STAFF REPORT
COMMUNITY DEVELOPMENT DEPARTMENT

HEARING DATE: 04/7/2026
TO: Mayor & City Council
FROM: Sonya Allen, Associate Planner
sallen@meridiancity.org
SUBJECT: Apex Cadence No. 1 – FP
FP-2026-0001
LOCATION: 6575 S. Locust Grove Rd., in the NE 1/4
of Section 6, T.2N., R.1E. (Parcel
#S1406110355)

Final plat consisting of 112 building lots and 27 common lots on 5.10 acres in the R-15 zoning district for the first phase of Apex Cadence Subdivision.

PLAT OF
APEX CADENCE SUBDIVISION No. 1
A PORTION OF THE EAST 1/2 OF THE NORTHEAST 1/4 OF SECTION 6,
TOWNSHIP 2 NORTH, RANGE 1 EAST, B.M.,
CITY OF MERIDIAN, ADA COUNTY, IDAHO.
2026

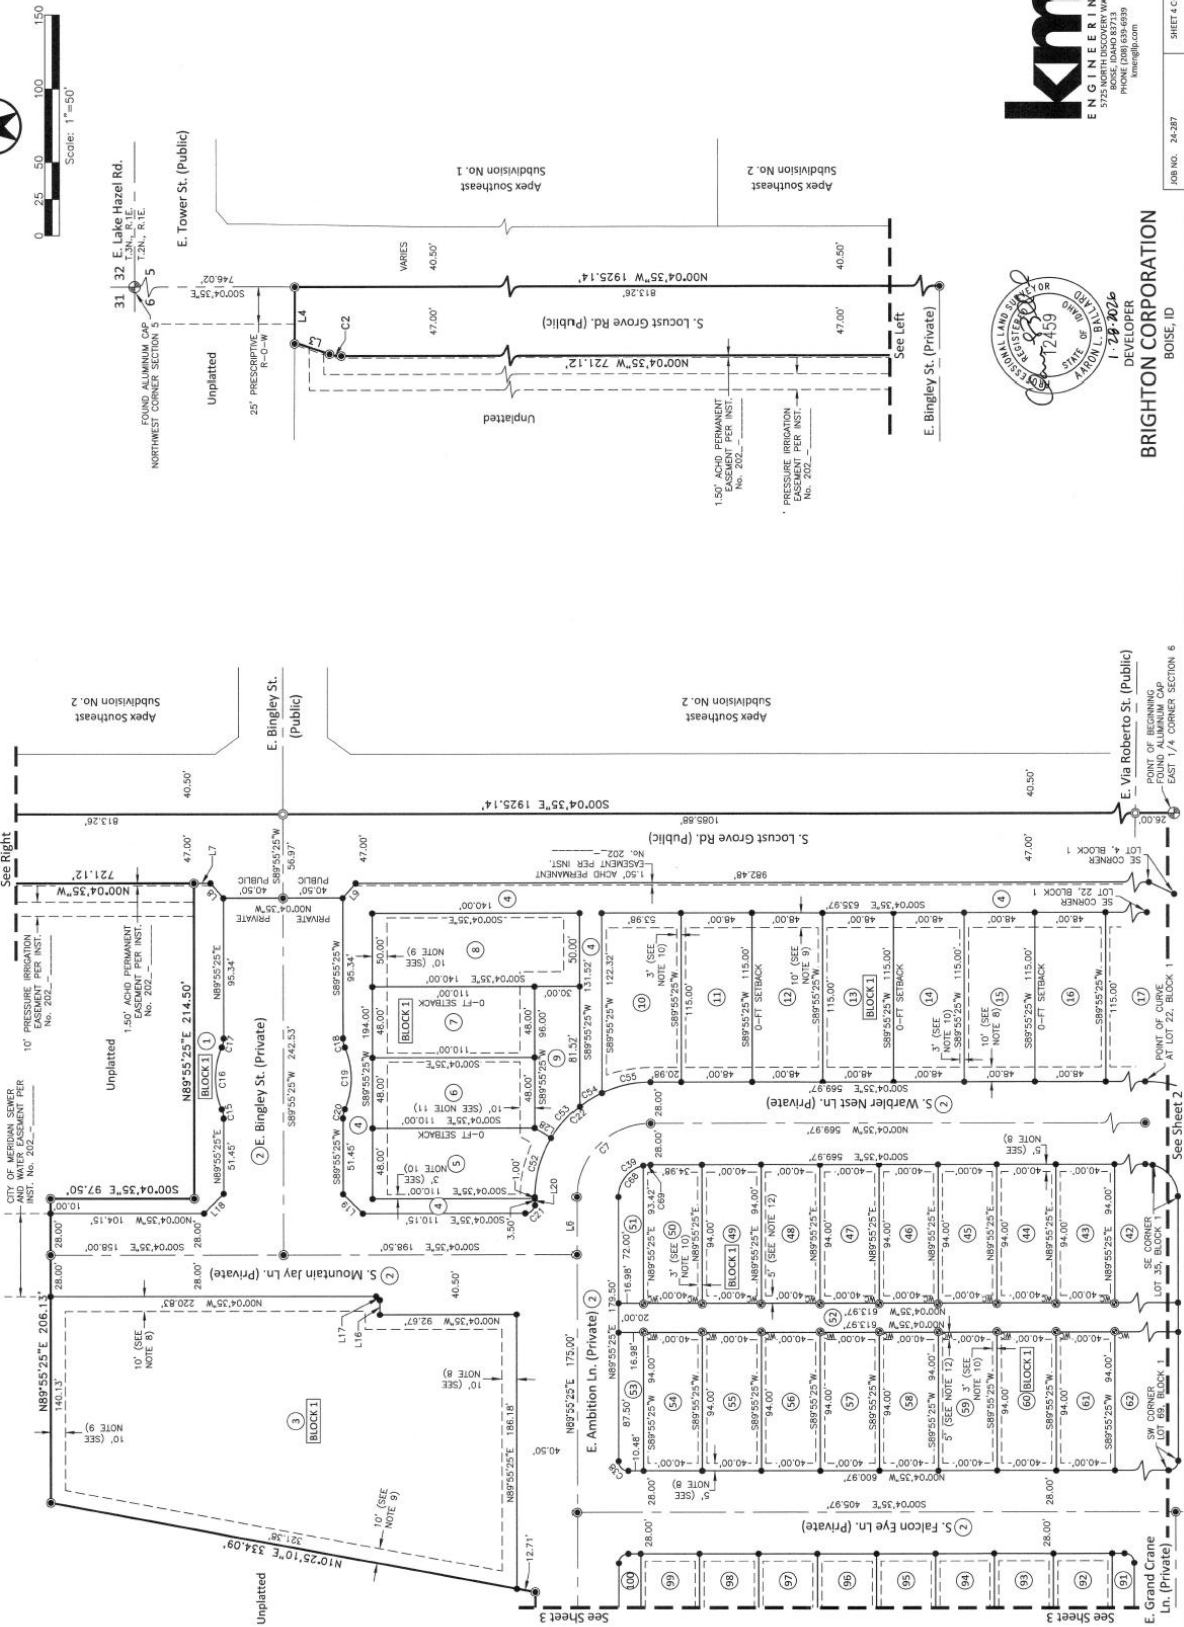
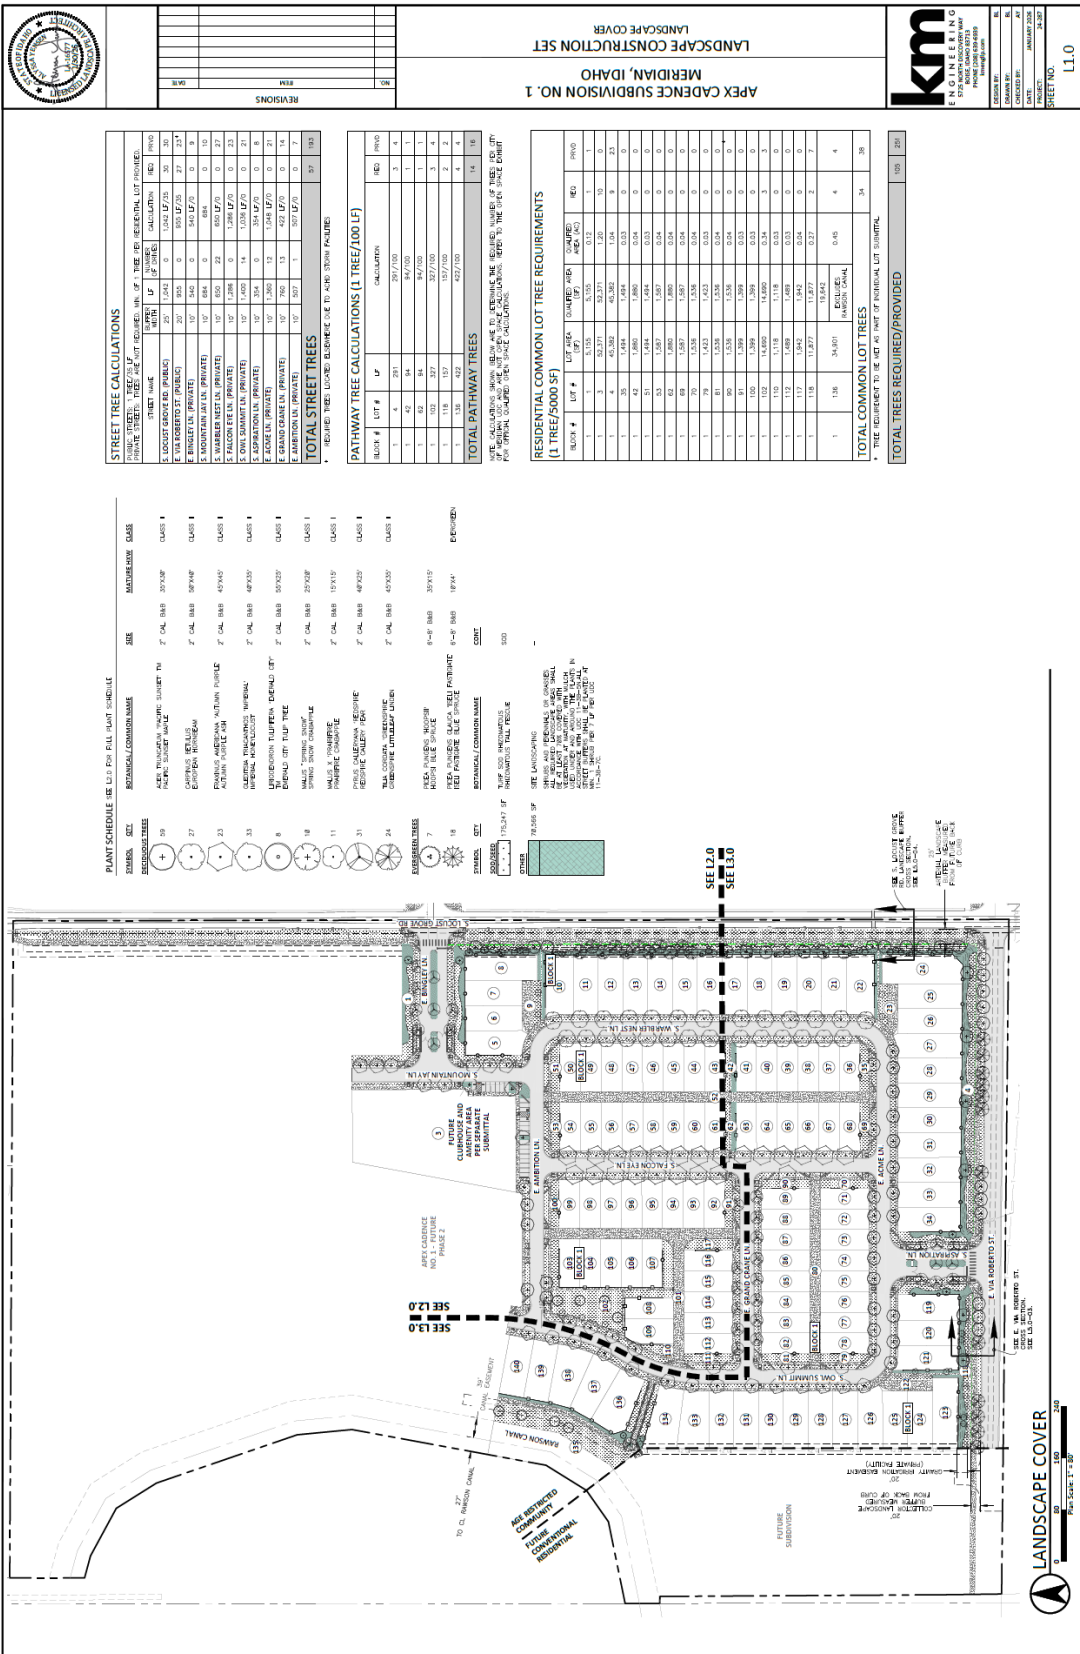
- a. Note #5: Lot 136 should be Lot 135, Block 1
 - b. Note #6: Include that the private street shall provide perpetual ingress-egress to all lots in the subdivision.

- c. Note #7: Lot 123 should be 122; and Lots 124, 125 & 126 should be 123, 124 & 125
 - d. Note #11: Lot 123 should be 122
 - e. Note #14: Include the recorded instrument number of the ACHD temporary license agreement

- f. Include the recorded instrument number of the City of Meridian sewer and water easement graphically depicted on Sheets 2, 3 and 4.
 - g. Include the recorded instrument number of the ACHD permanent easement graphically depicted on Sheet 2, 3 and 4.

- h. Include the recorded instrument number of the 10' pressure irrigation easement on Sheet 4.
 - i. Depict a 14-foot wide public use easement for the multi-use pathway along the Rawson Canal on Lot 135, Block 1 outside of the irrigation easement unless permission is specifically obtained from the governing irrigation district; include the recorded instrument number of the easement on the plat.

- j. If the multi-use pathways/sidewalks along E. Via Roberto St. and S. Locust Grove Rd. aren't located entirely within the right-of-way, public use easement(s) shall be depicted on the plat.

- k. Depict a minimum 10-foot-wide multi-use pathway along the Rawson Canal in Lot 135, Block 1 in accord with UDC 11-3A-8G and the Pathways Master Plan.

- l. Depict the easement for the Watkins Drain.

APEX CADENCE SUBDIVISION NO. 1
MERIDIAN, IDAHO
LANDSCAPE CONSTRUCTION SET
FENCE PLAN

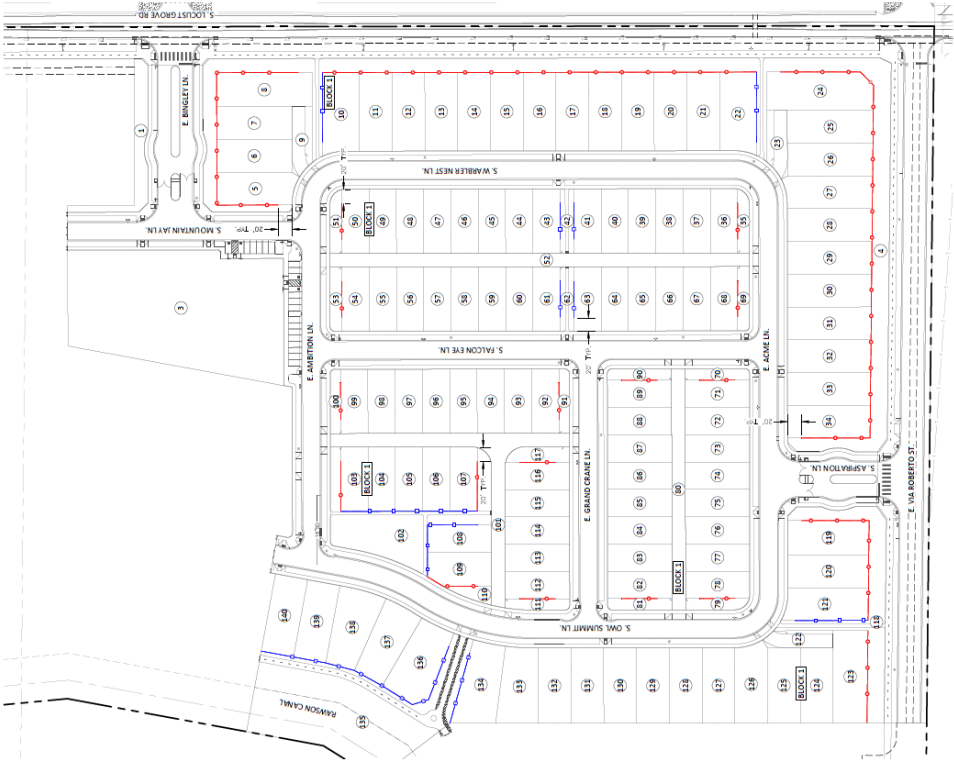
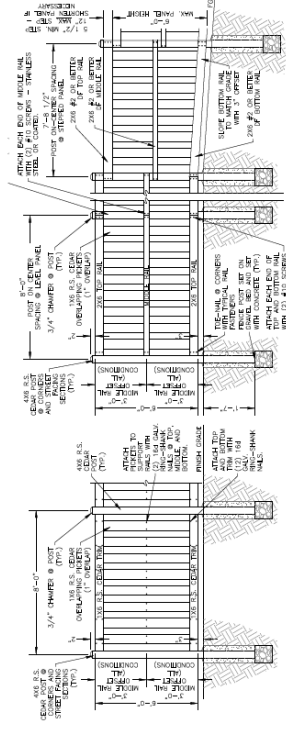
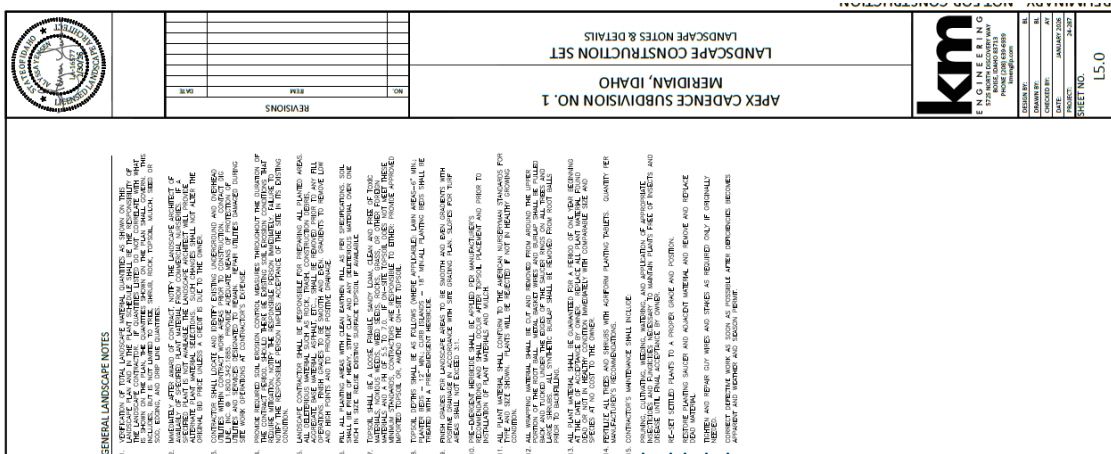
A copy of the revised plat shall be submitted with the final plat for City Engineer signature.
5. The landscape plan prepared by KM Engineering, dated 01/30/2026, included in Section V.C, shall be revised as follows:
 - a. Depict enhanced landscaping within the street buffers along S. Locust Grove Rd., an arterial street, and E. Via Roberto St., a collector street, in accord with the standards listed in UDC 11-3B-7C. and 11-3G-3B.3. Include a note stating what the enhanced landscaping consists of.

- b. Include calculations for the required number of trees within the parkways along internal private streets that demonstrate compliance with the standards in UDC 11-3A-17E, 11-3B-7C and UDC 11-3G-3B.4.
- c. Widen the multi-use pathway to 10-feet along the Rawson Canal in Lot 135, Block 1 in accord with UDC 11-3A-8G and the Pathways Master Plan.
- d. Widen the detached sidewalks to 10-feet within the street buffers along S. Locust Grove Rd. and E. Via Roberto St.
- e. Include tree mitigation calculations on the landscape plan in accord with the standards in UDC 11-3B-10C.5, as applicable.
- f. Depict a minimum 5-foot wide landscape strip on each side of all pathways as set forth in UDC 11-3B-12C.1; or submit an application for alternative compliance to this standard.

E. Common Driveway Exhibits – NOT APPROVED

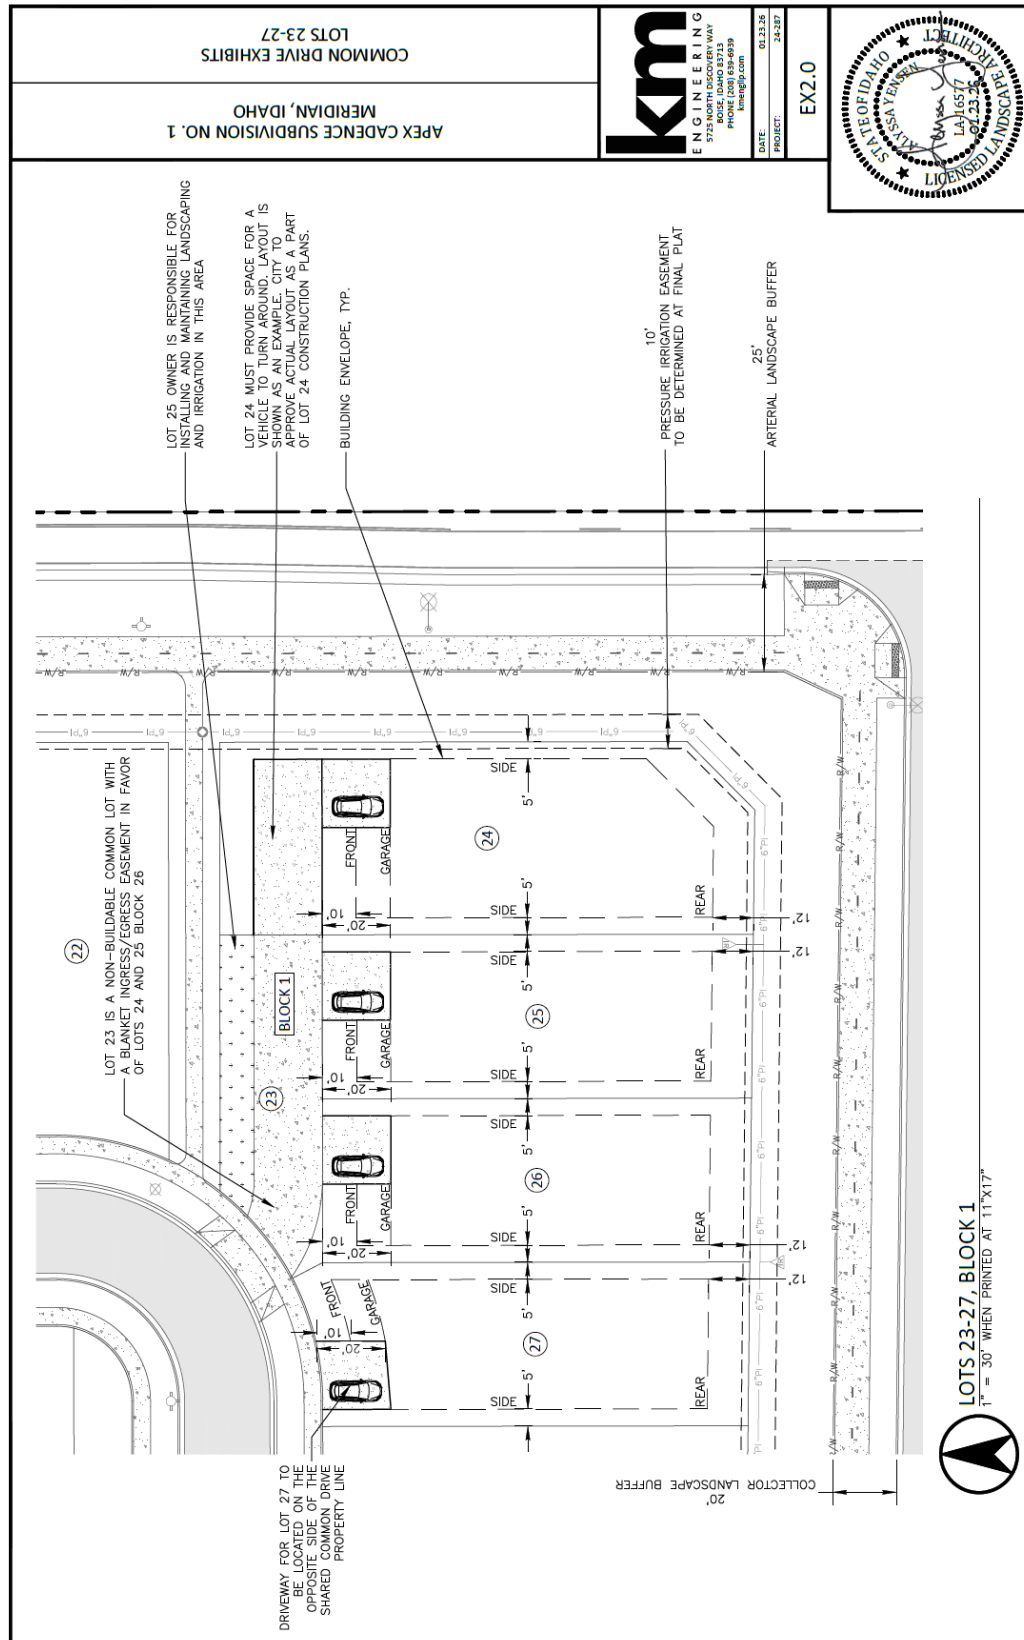
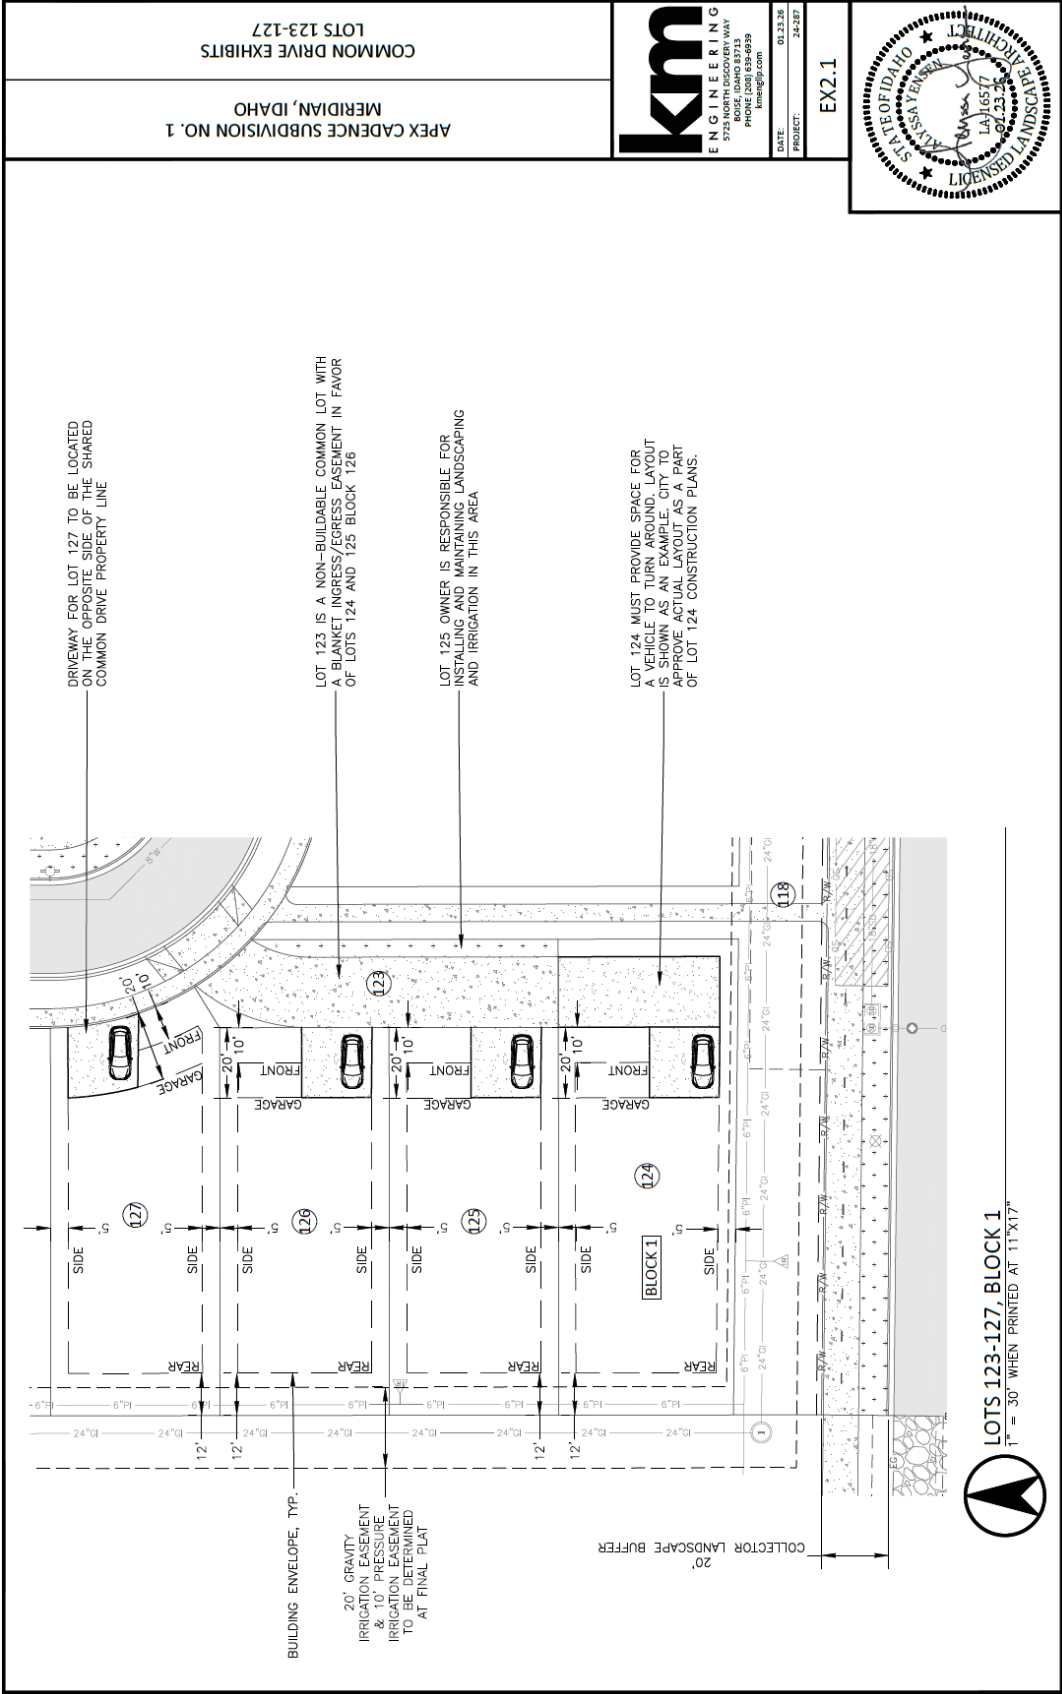
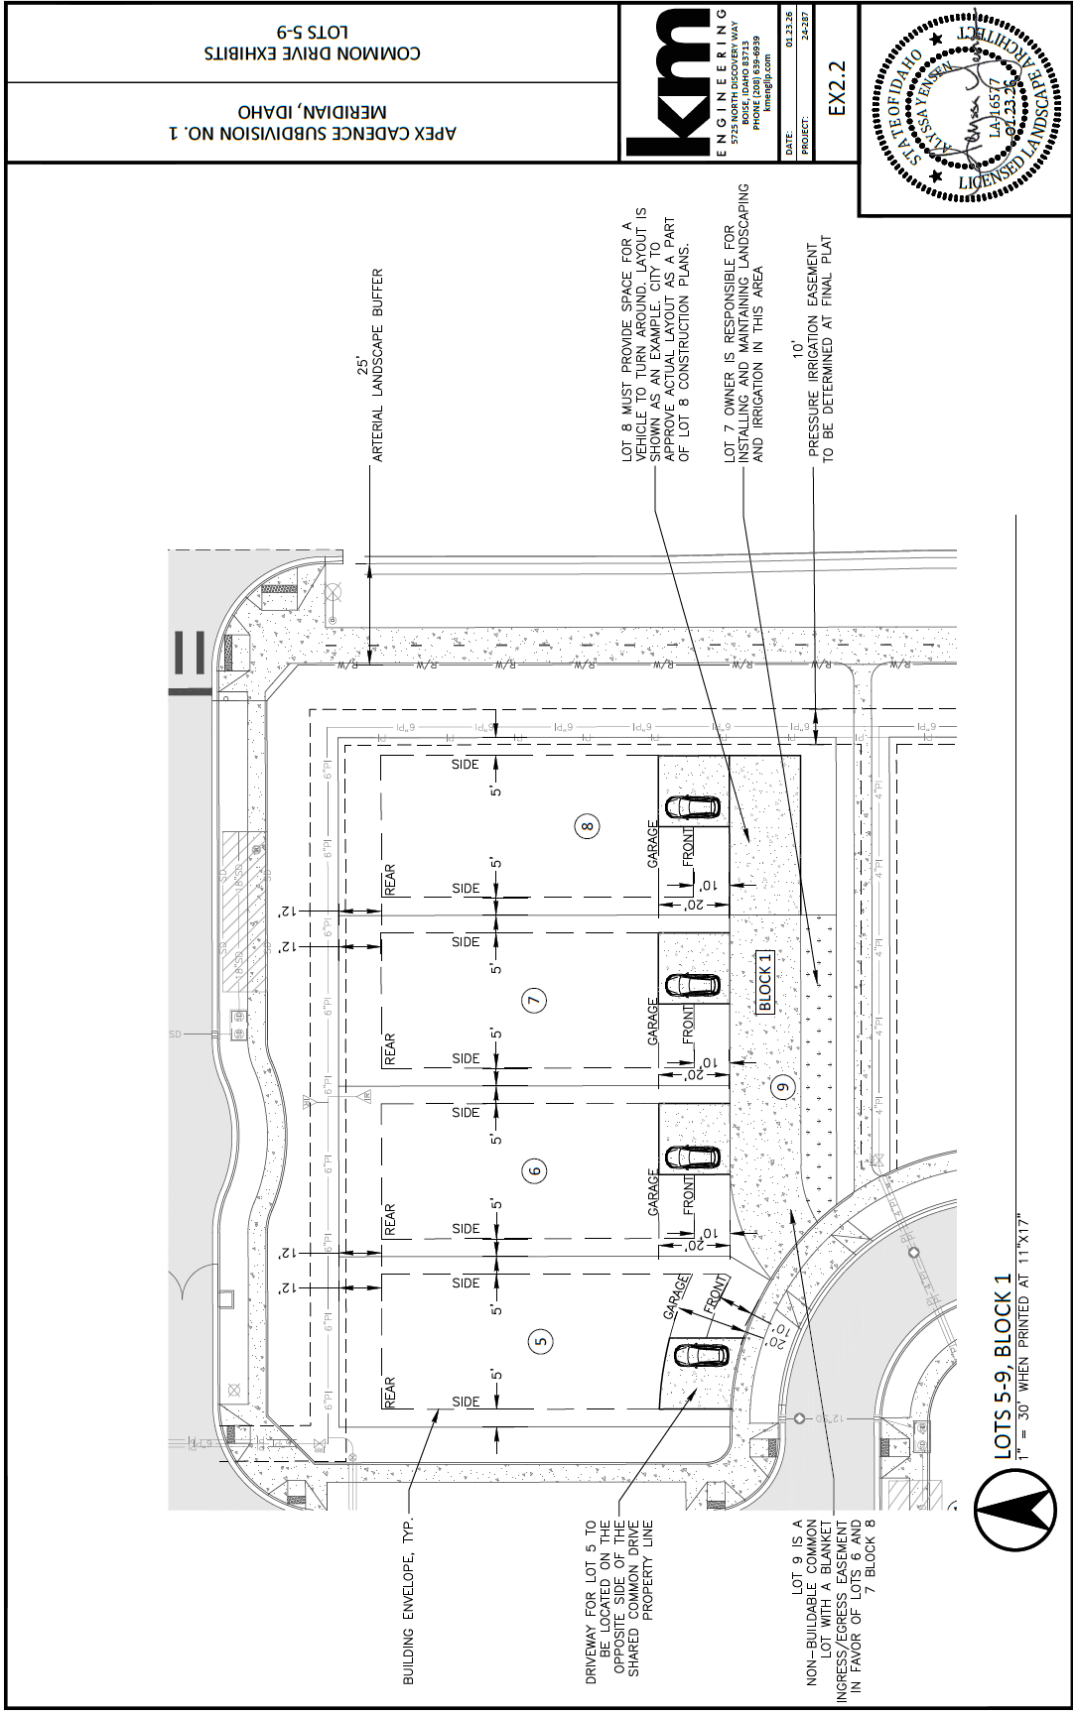
20. The common driveways on Lots 9, 23 and 122, Block 1 shall be constructed in accord with the standards listed in UDC 11-6C-3D. **The common driveway exhibits included above in Section V.E shall be revised as follows: delete the note requiring the property owner to install and maintain landscaping and irrigation in the landscape area along the common driveway – the developer is responsible for installing irrigation and landscaping in these areas and the Homeowner’s Association is responsible for maintaining these areas.**
